RE: Schwartzwalder Mine; DRMS File No. M-1977-300; Technical Revision (TR-23)

#### COTTER CORPORATION (N.S.L.) SCHWARTZWALDER MINE, GOLDEN, COLORADO PERMIT NO. M-1977-300 RESPONSE TO COMMENTS REGARDING TECHNICAL REVISION 23 (TR-23)

#### December 23, 2016 Comment Letter

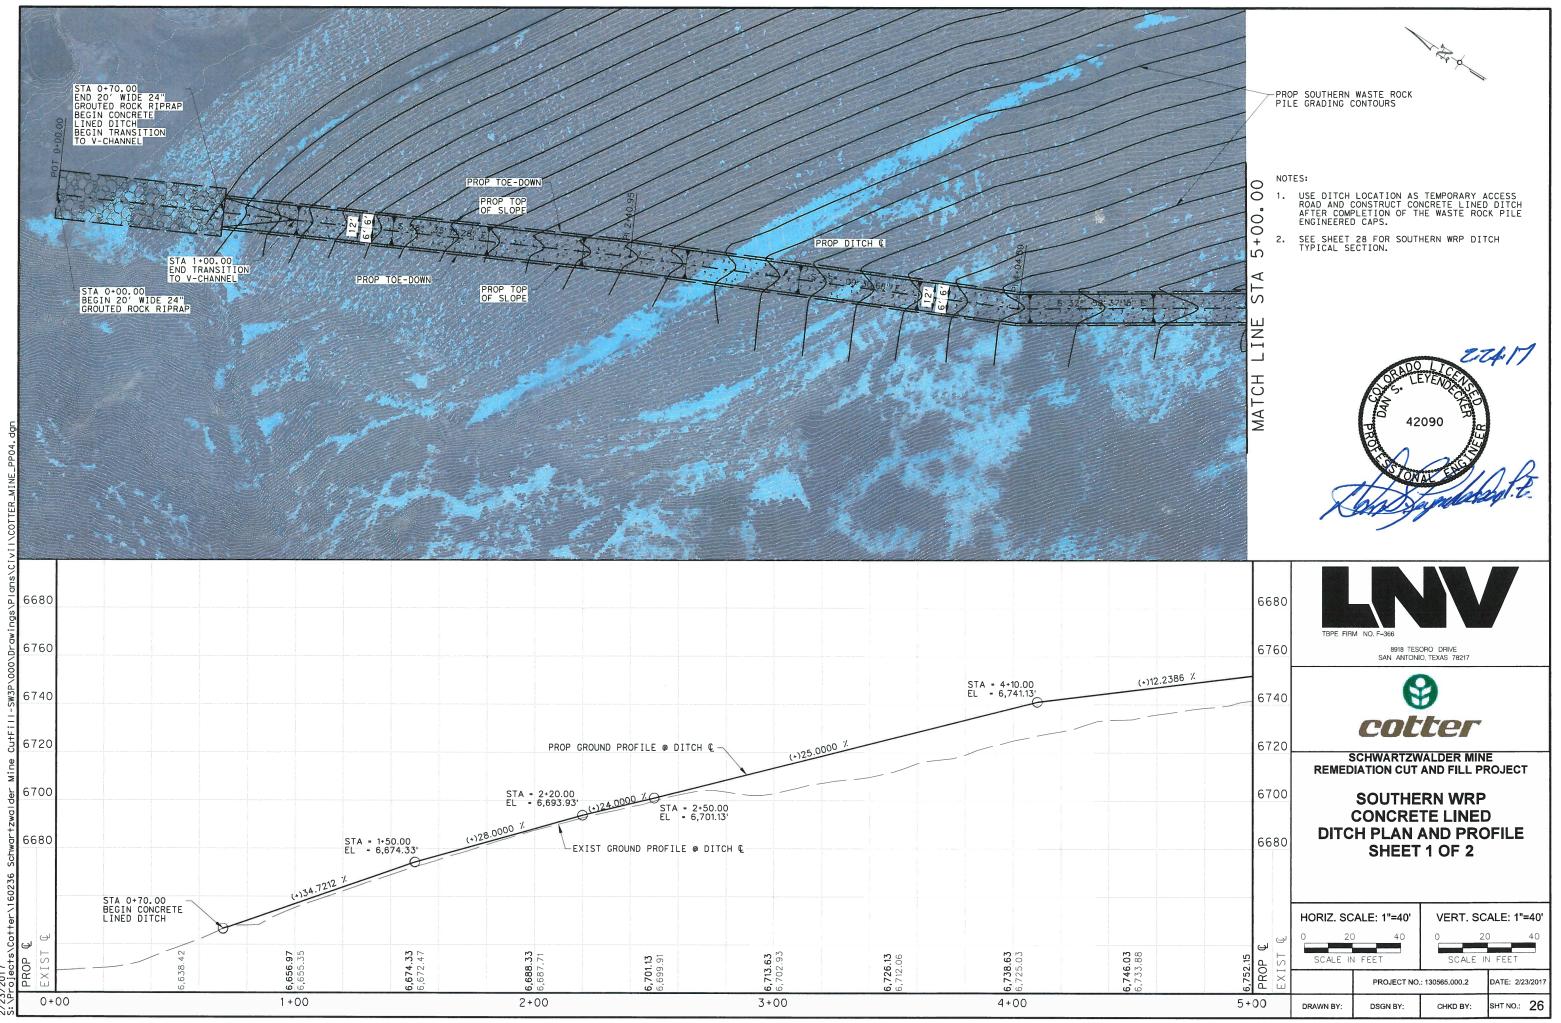
3. The design drawings show the storm water diversion ditches terminate several feet above the toe of slope of the WRP's. The design should include a means to safely convey the diverted flow from the base of the diversion ditches to Ralston Creek. Please describe how storm water will be safely conveyed to Ralston Creek so that erosion of the WRP's or the access roads does not occur.

7. The Division requests detail call-outs for all plan profiles for Sheets No. 22-28 of the design drawings. All features should be labeled on the detail call-outs and referenced on the plan and profile drawings.

The diversion ditches have been updated as shown on the revised Attachment C, sheets 22-27. The Southern WRP diversion ditch will end to the North of the cut off dam and will be protected with concrete riprap to allow the water to flow to the Ralston Creek. Surface water will not flow over the access road Cotter submitted a response to the Division's Adequacy Review #1, Comment # 18 on November 8, 2016 As a result of the update of the diversion ditch design, this response has been changed and is included in Attachment G, a February 23, 2017 report form Engineering Analytics, Inc. One of the primary changes is the

Additional callouts have been added to Sheets 22-29 to clarify the link between the plan and profile sections and the diversion ditch typical sections and details.

WRP V-CHANNEL CAPACITY CALCULATIONS

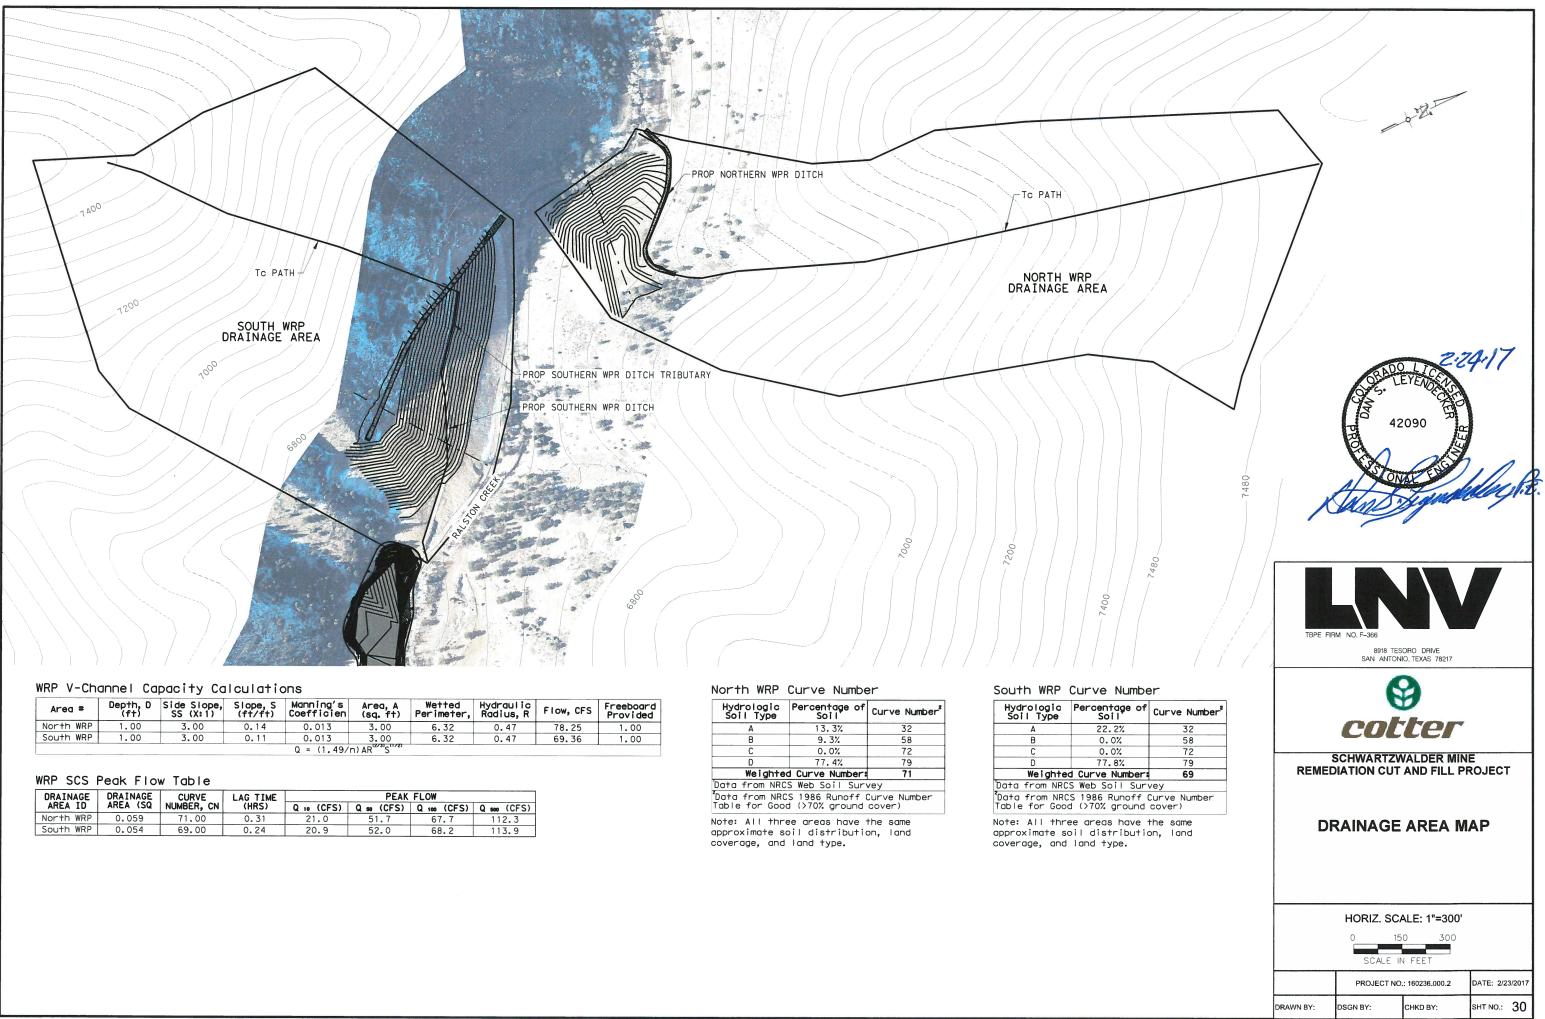
5. The design drawings for the storm water diversion ditches do not address freeboard. Please indicate if the design of the storm water diversion ditches accounts for freeboard. If so, specify the freeboard. The Division recommends the design provide for one foot of freeboard or half the velocity head.

> The hydraulic calculations have been added to Sheet 3 of 3 of the Concrete Lined Ditch Miscellaneous Detail sheets, Sheet 31 in the plans. One foot of freeboard has been provided for both diversion ditches.
